# Access Compliance Report

## Public Rights-of-Way

Intersection ID: 53893	Main Street: PERTH_MOOR_RD	Cross Street: HAMILTON_BRIDGE_RD	Location: NE
ADA ID: 2A00CAA4898E	Ramp Type: BlendTrans1	Initial Pass/Fail: Fail	Overall Compliance: No
			Severity Score: 21.25

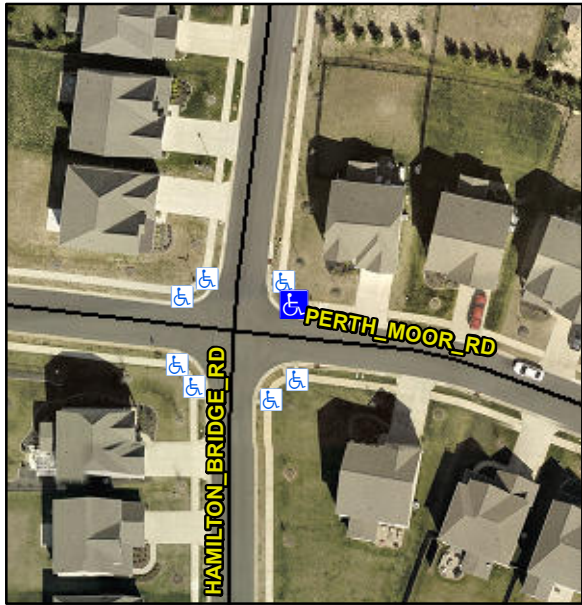
Codes/Mitigation Info/Possible Solution			Field Measurements/Component Compliance					
	Possible Solutions:		Compliance	Description	Data	Compliance	Description	Data
	Remove & Replace Curb Ramp With Two New Directional Ramps or Equivalent.		N/A	Ramp Length (in)	46.5	Yes	BlendTrans Slope (%)	2.7
			No	Ramp Width (in)	47.0	No	BlendTrans XSlope (%)	5.2
			N/A	Flare Type LT	N/A	N/A	Flare Type RT	N/A
			N/A	Flare Slope LT (%)	N/A	N/A	Flare Slope RT (%)	N/A
			N/A	Flare Traversable LT?	N/A	N/A	Flare Traversable RT?	N/A
			N/A	Landing Length (in)	N/A	N/A	DWS Provided?	N/A
			N/A	Landing Width (in)	N/A	N/A	DWS Contrast?	N/A
			N/A	Landing Slope (%)	N/A	N/A	DWS Length (in)	N/A
			N/A	Landing X Slope (%)	N/A	N/A	DWS Full Width?	N/A
Surveyor Notes:	N/A		N/A	Landing Curb? (Y/N)	N/A	N/A	DWS Offset (in)	N/A
			N/A	Shared Landing?	N/A			
			N/A	Gutter Ponding?	N/A	N/A	Gutter Slope (%)	N/A
			N/A	Gutter Lip Ht (in)	2.0	N/A	Gutter X Slope (%)	N/A

N/A	Painted X Walk1?	No	N/A	Painted X Walk2?	N/A
				X Walk 1 Direction	To S		X Walk 2 Direction	N/A
				X Walk 1 Width (in)	N/A		X Walk 2 Width (in)	N/A
				X Walk 1 Slope (%)	2.3		X Walk 2 Slope (%)	N/A
				X Walk 1 X Slope (%)	5.6		X Walk 2 X Slope (%)	N/A
			N/A	Ramp inside XWalk1?	N/A	N/A	Ramp inside XWalk2?	N/A
PROW/ADA:	Not Found, R304.5.1, R304.5.3			Road Slope (%)	5.6		Clear Space?	N/A
				Road X Slope (%)	2.3	N/A	Clear Space to XWalk (in)	N/A
			N/A	Any Obstructions?	N/A	N/A	Storm Grate/Utility Hazard?	N/A
				Obstruction Type			Storm Grate/Utility Type	
					N/A			N/A
						Yes	Surface Condition? (G/P)	Good
						No	Curb Slope (%)	10.9
Total Cost:		\$	3200.00
